OREGON STATE UNIVERSITY (OSU)

DEARBORN HALL

ADA ASSESSMENT & SURVEY

Re: ADA Accessibility Survey and Assessment - Dearborn Hall

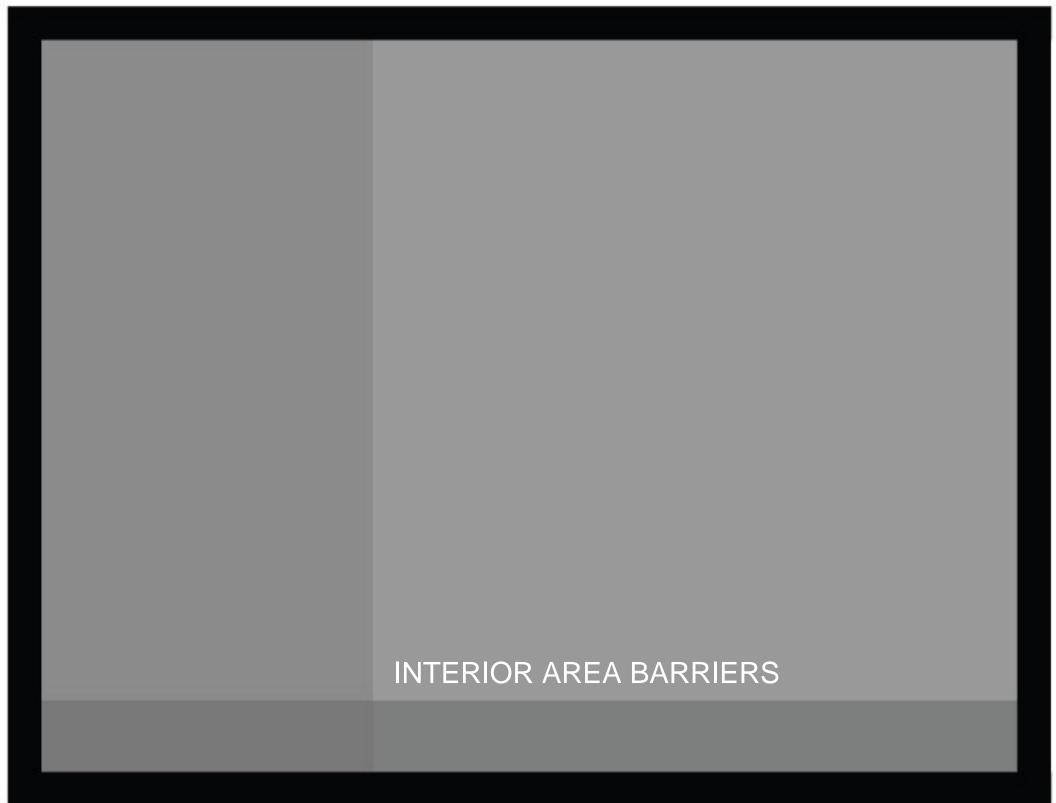
Barrier Type:	Vertical Access - Ramp
Code References:	2010 ADAS 403.1
Performance Sta	ndard: No Quantity: SF As-built : 0
Barrier Description:	No form of vertical access provided at stairway to reach upper floors
Findings:	No form of vertical access provided at stairway
Rec. Solution:	Provide a ramp to reach door landing
Barrier Severity:	
	1 Necessary Cost Est \$0.00 Facility Function: Public Status: Open
Implementation
